APPLICATION FOR APPEAL, REHEARING, OR REVIEW

*Old Business 8a, Meeting of August 22, 2013
Fairview Park Entry way + Parking Lot, etc.*

SUBJECT: FAIRVIEW PARK ENTRYWAY CONCEPT PLANS

FAIRVIEW PARK: CONCEPTUAL SITE PLAN B

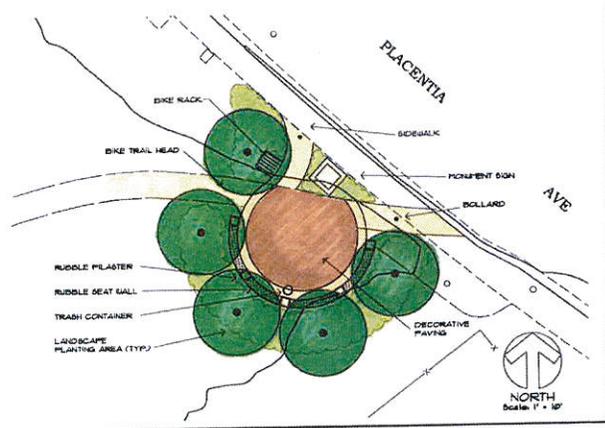
*Concern re: Consistency with Master Plan
Impact on park resources
due to various elements,
including parking lot + play area
Impact on community
Appropriateness + practicality of
plant palette*

Mr. Mehren suggested the tot lot is misplaced and needs covering, and there are no restroom facilities nearby. Mr. Mehren believes the parking lot is too close to homes and should be placed 150-feet into the park.

The tot lot should be moved to the parks major entryway. The parking lot is too close to homes.

After reviewing the masterplan and listening to tonight's presentation, Ms. Manfredi believes the parking lot is four times the original plan and the tot lot is five times larger than the original plan. She recommended a parking study to see if a parking lot is necessary.

The ten-space parking is close to a bluff failure. The playground does not have bathrooms and he suggested workout equipment instead.

Commissioner Graham requested Conceptual Plan B be displayed. The outlined vernal ponds and the water run east to west, and he inquired of Mr. Mejia if the flow of water will go through that area.

Ms. Kabbara addressed the layout for the end of Pacific. The urban search and rescue vehicle is one of the largest vehicles that could possibly be used and the layout of the parking lot on Pacific accommodates the vehicle. The fire department suggested their preference for this layout. If the City wished to restrict use of the cul-de-sac for their larger vehicle; the 25' wheelbase can be utilized.

Mr. Mejia indicated when there is a big enough storm, the water flows into the marshes.

MOTION made by Chair de Arakal, seconded by Vice Chair Pederson, carried four to one, with Commissioner Graham voting no, to approve Conceptual Plan B.
